# CITY OF ALBUQUERQUE

**Re: Starbuck Drive-Thru**  
**1314 Gibson Blvd. SE Albuquerque NM 87106**  
**Traffic Circulation Layout**  
Engineer's/Architect's Stamp 01-16-20 (L15D041)

**SITE TRAFFIC CONTROL & LAYOUT PLAN**

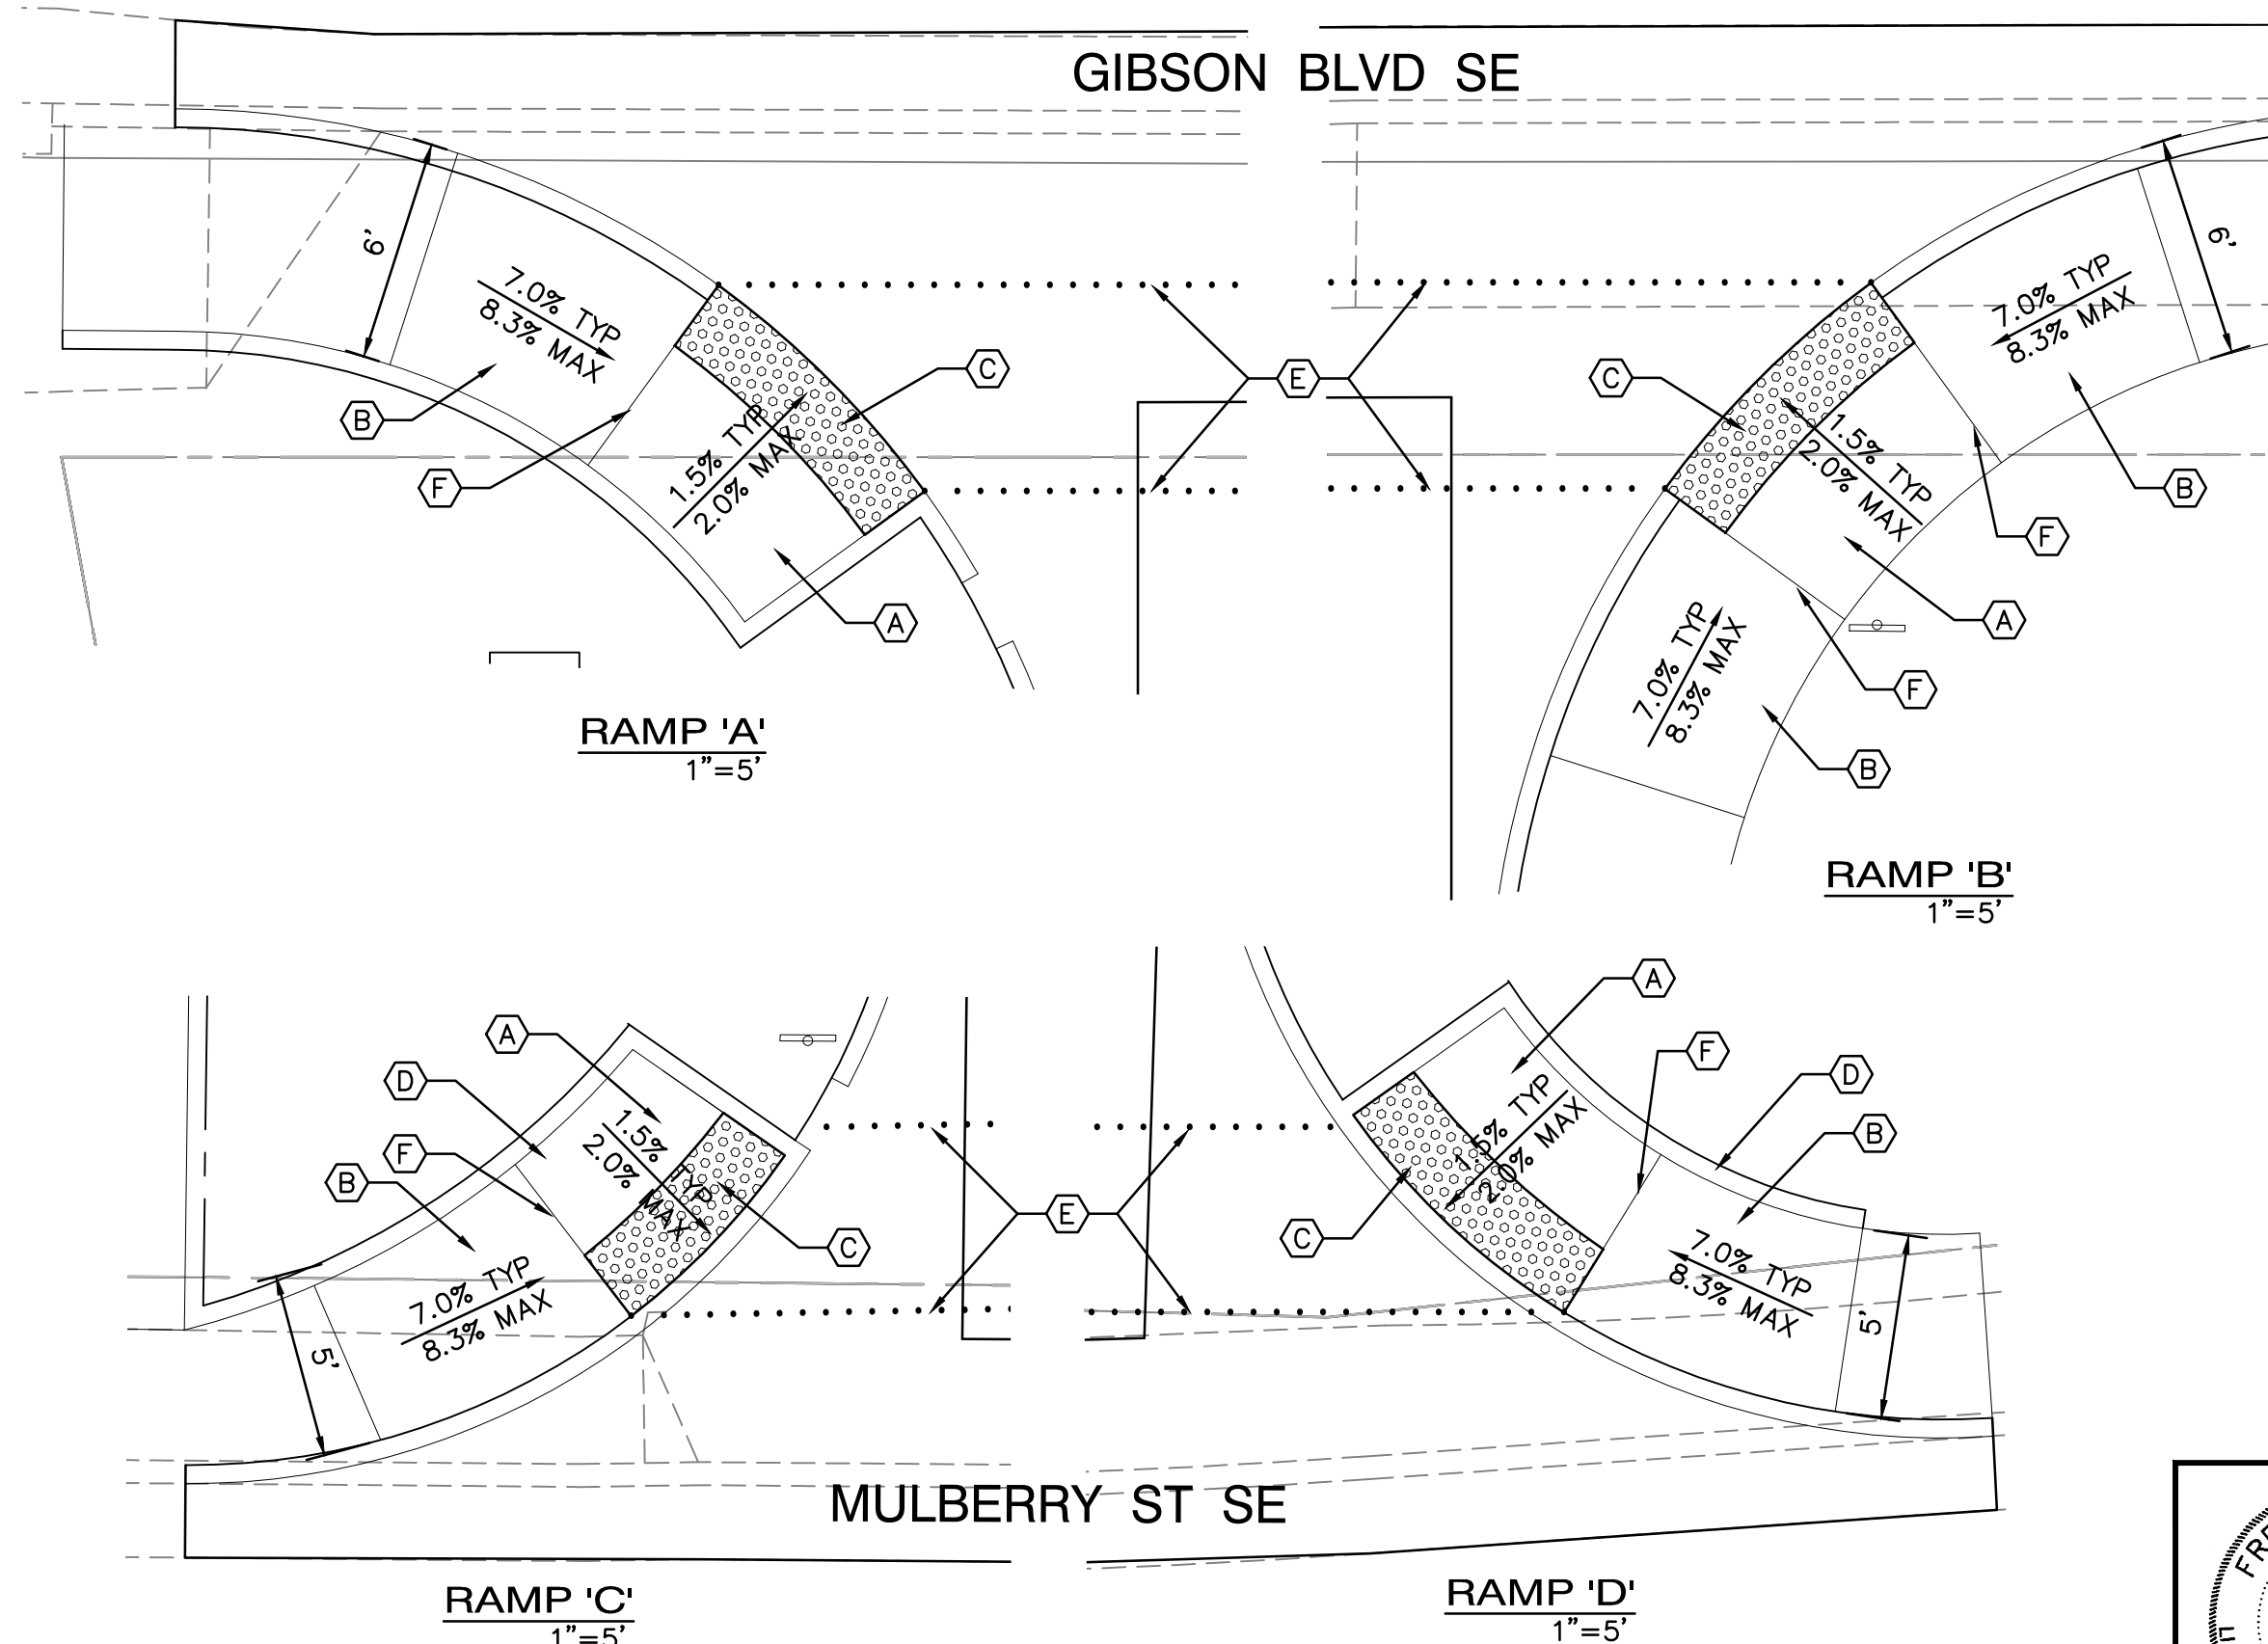
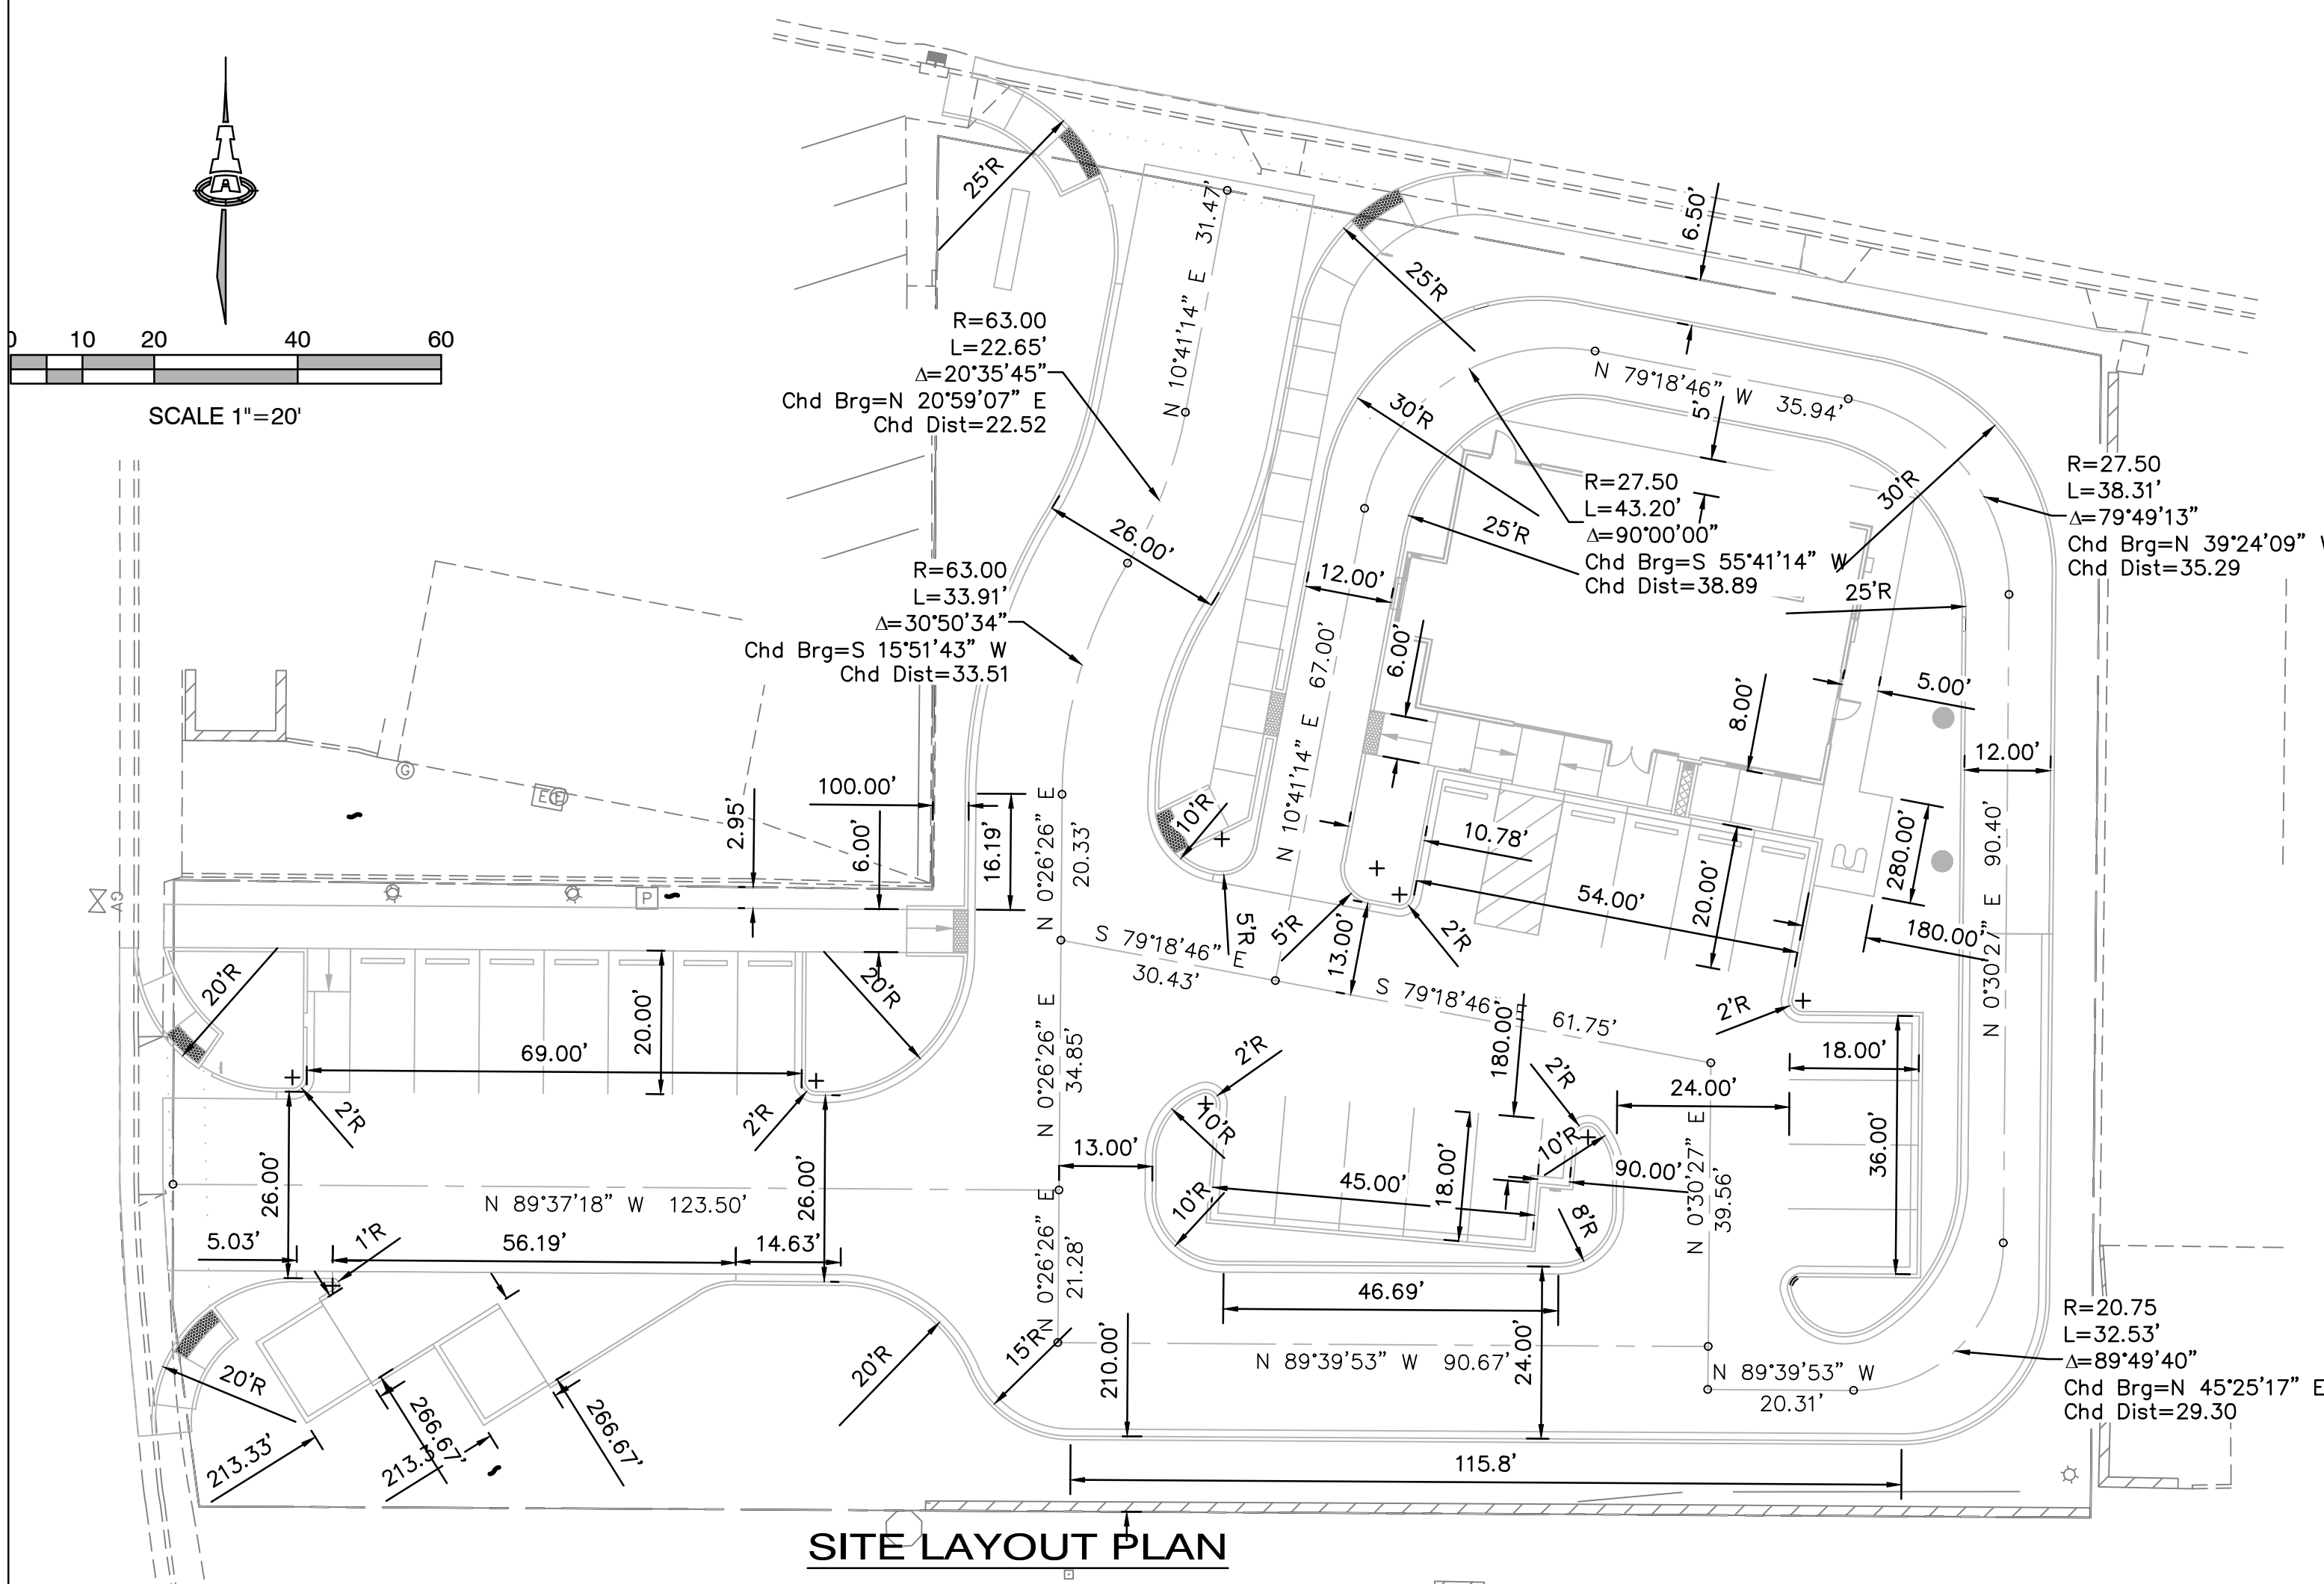
1. Please show a vicinity map showing the location of the development in relation to streets and well known landmarks.
2. List the number of parking spaces required by the zoning code as well as the proposed number of parking spaces including bicycle and motorcycle parking.

3. The ADA accessible parking sign must have the required language per 66-7-352.4C NMSA 1978 **"Violators Are Subject to a Fine and/or Towing."** **Please call out detail and location of signs.**

4. Please show the bike rack detail.
5. Refuse vehicle maneuvering shall be contained on-site. The refuse vehicle shall not back into the public right of way.; **provide a copy of refuse approval.**

6. It is not apparent what type of pavement surface is being proposed. A hard driving surface will be required as part of this proposed project for parking area and drive aisles.

7. All one-way drives shall have **"One Way"** and **"Do Not Enter"** signage and pavement markings. Please show detail and location of posted signs and striping.

8. Show the clear sight triangle and add the following note to the plan:  
"Landscaping and signage will not interfere with clear sight requirements. Therefore, signs, walls, trees, and shrubbery between 3 and 8 feet tall (as measured from the gutter pan) will not be acceptable in the clear sight triangle.

9. Unused curb cuts must be replaced with sidewalk and curb & gutter. A build note must be provided referring to the appropriate City Standard drawing.

10. Add a note stating "All broken or cracked sidewalk must be replaced with sidewalk and curb & gutter." A build note must be provided referring to the appropriate City Standard drawing.
